20221047.1/1307A/R0/PF

Warringah Golf Club - Response to RFI

This letter is to response Northern Beaches Council 's queries and comments (dated 13 June 2023) with regard to acoustic impacts associated with the newly proposed golf club house and associated facilities at 292 Condamine Street, North Manly. The comments are reproduced below:

Figure 1 – Section of SEPP Map 12 showing project locations and adjacent roads

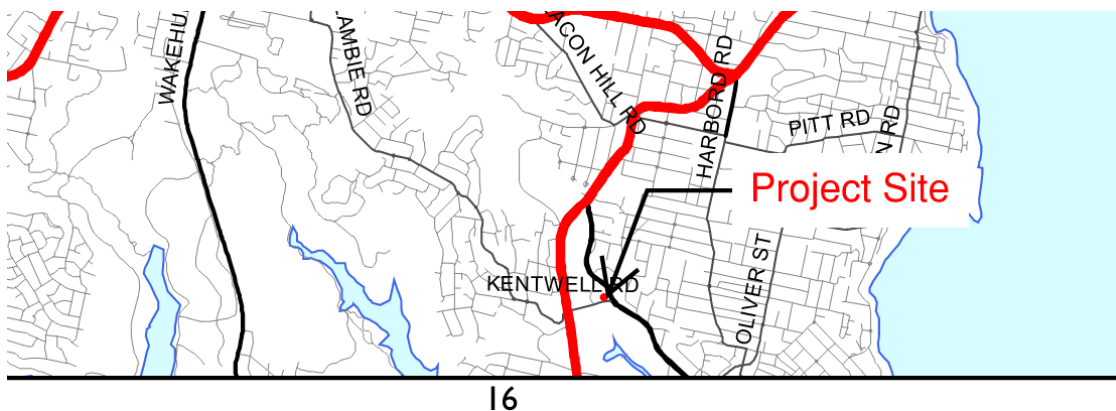
The site shares a frontage with a classified road being Pittwater Road and Kentwell Road and is pursuant to the provisions prescribed by Clause 2.119 of the SEPP. To satisfy subclause 2.119(c) of the SEPP Council requires the applicant to demonstrate whether:

(c) the development is of a type that is not sensitive to traffic noise or vehicle emissions, or is appropriately located and designed, or includes measures, to ameliorate potential traffic noise or vehicle emissions within the site of the development arising from the adjacent classified road.

A written statement or amendments to the plans detailing the type of mitigation measures is required to enable Council to discharge this pre-condition.

Furthermore, the definition of busy road is also changed to AADT more than 20,000 vehicles and a noise descriptor of $L_{eq(periode)}$ should be applied for assessment. It is noted that Map 12 of the traffic volume maps for the SEPPT&I 2021 on RTA website does not identify any adjacent streets (namely Kentwell Road and Pittwater Road) around the site as a road that carries an annual average daily traffic (AADT) greater than 20,000 vehicles. Hence clause 2.120 will not need to be satisfied.
